## PRODUCT CHANGE NOTIFICATION

#PCN-ION-HDCP-14

Business Unit	Product Line Code	Type of Change	Action	Date of issue
ION	CNA	Software	Notify Distributors and Field	12/15/2014

**1) Unconnected function blocks connect when shifting or deleting networks after using “integrate further safety networks” function in SAFECNF safety software.**

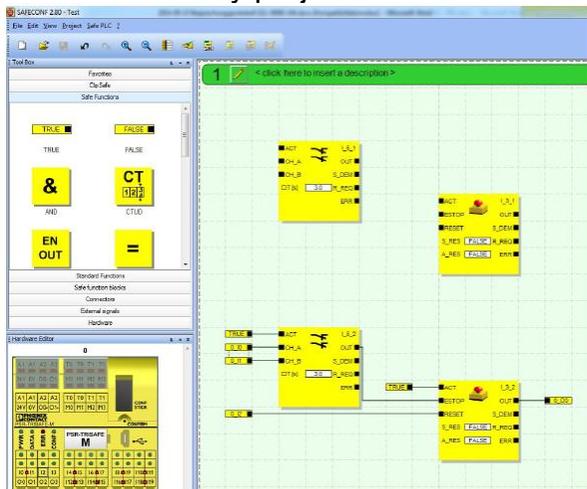
**Affected SAFECNF software versions: 2.4, 2.5, 2.6, 2.7, 2.7.1, 2.7.2, 2.8**

If all of the following prerequisites are met when creating the safety logic, it may be possible for unconnected inputs or outputs of function blocks to be automatically connected, thus creating an unintended alteration to the logic.

It is highly unlikely that in your project creation, either of these sequences occurred; however, if you believe that you may be affected, please consider the detailed walkthrough below for each error and check your project to ensure you are not affected. Even though only a small fraction of actual projects will be affected, these errors occur in the safety related part of the control system, so **we are recommending that all customers uninstall SAFECNF 2.80 and install SAFECNF 2.90.**

1) Symmetrically built networks with the safety project

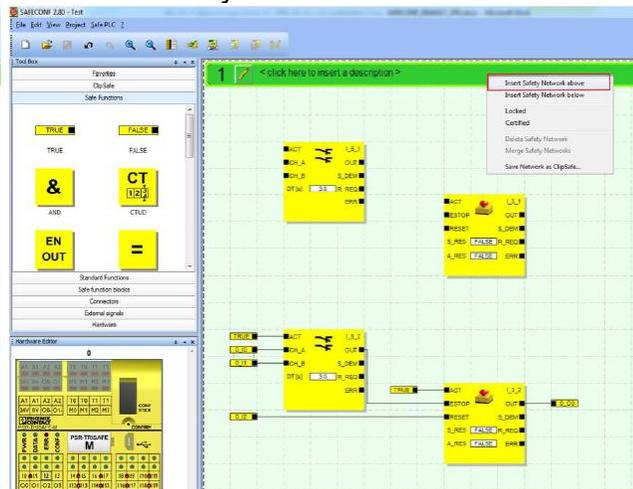
Prerequisites that must **all** be met:

3) Shift the network limits (b) and subsequently undo the changes via the program's 'Undo' function (c) to the initial situation 1.

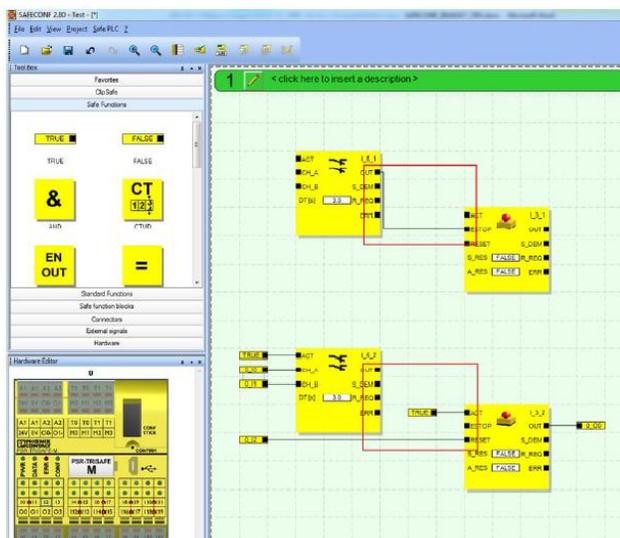
4) In very rare cases, the connecting line may have shifted.

Should **all aforementioned** prerequisites apply to the projects you created, then there is the possibility that an automatic regeneration of connecting lines takes place with a pixel-precise shifting of a symmetrically built project. In this case, please check your created safety logic since there might have been changes in this safety logic.

### 2) Separating double input signals within the SAFECONF workspace for Trisafe Projects and then using the undo button could switch the input configuration

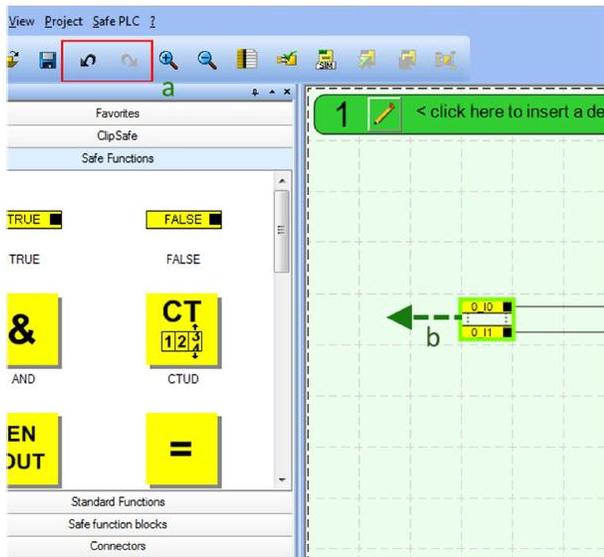
If you have used double signals interlinked with each other and separated them into individual signals by right-clicking in the graphical editor when creating projects for PSR-Trisafe, then the subsequent undoing of this separation might lead to a reversal of the order of input signals already connected to function blocks. Attached to this document please find an illustrated description.

1) Dual channel inputs are connected within the safety logic

2) Separate the double signals in the graphical editor via the context menu.

In order to avoid the described behavior in new projects and future changes of existing configurations, you need to change to the new version SAFECONF 2.90 to create new SAFECONF projects and modify existing SAFECONF projects.

3) Undo using the 'Undo' function (a) and subsequent shifting of the double signal (b).

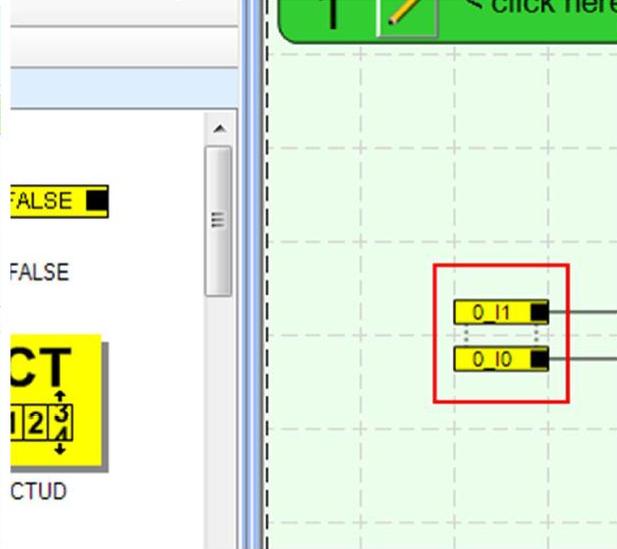
4) Then the project must be stored. After reopening, the input signals might have been exchanged.

Should the aforementioned description of the procedure apply to your SAFECONF projects, then there is the possibility that the mode of operation of your safety logic has been changed. In this case, please check the safety logic and safety functions in your application for correctness with regard to your specification.
